Customer Safety Advisory Notice CT004/22/S

Subject: Silent change of default Patient Marking workflow setting after upgrading to new RT Image Suite version with syngo.via VB60 or syngo.CT VA40 software

Fig. 1: Comparison of default workflow setting in VB60 and previous versions (example: VB50).

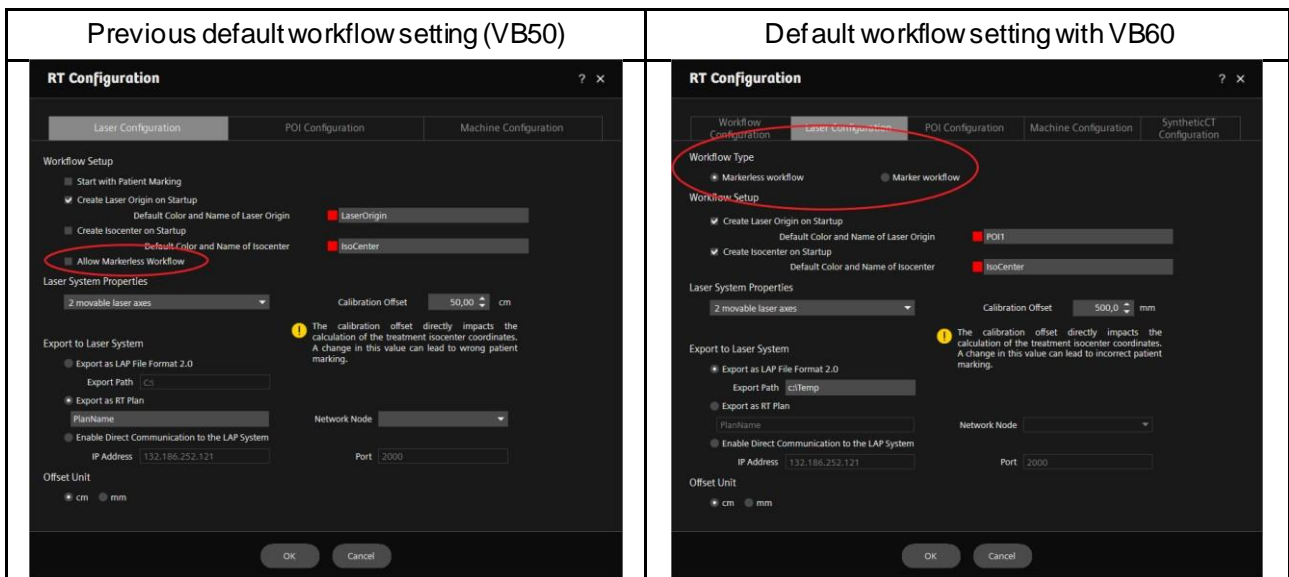
In RT Image Suite versions prior to syngo.via VB60 / syngo.CT VA40, the Workflow Setup “Allow Markerless Workflow” was deactivated by default in the Laser Configuration settings (c.f. fig.1 below, left column). After upgrading RT Image Suite to VB60, this setting is automatically, and without explicit notification, changed to “Markerless workflow” in the new “Workflow Type” section in the Laser Configuration settings with VB60 (c.f. fig. 1 below, right column).

If a marker-based workflow was used prior to the upgrade, then following the upgrade the laser offset coordinates in the Patient Marking step are no longer calculated based on the marker position. If the radiopaque markers are not placed at the laser zero position as described in the "Instructions for Use" (IFU), this may lead to the wrong laser offset coordinates being displayed in the Patient Marking step.

After upgrading RT Image Suite to VB60, please check the Laser Configuration settings in the RT Configuration and adjust the Workflow Type according to your actual workflow. Additionally, it is generally recommended that you "perform a quality assurance procedure after any change to the external laser system or any change to the software application" (c.f. IFU chapter 2.6 and 4) to ensure that the laser coordinates are correctly calculated.

It is sufficient to check that the default Workflow Type is correct. There is no technical update needed.
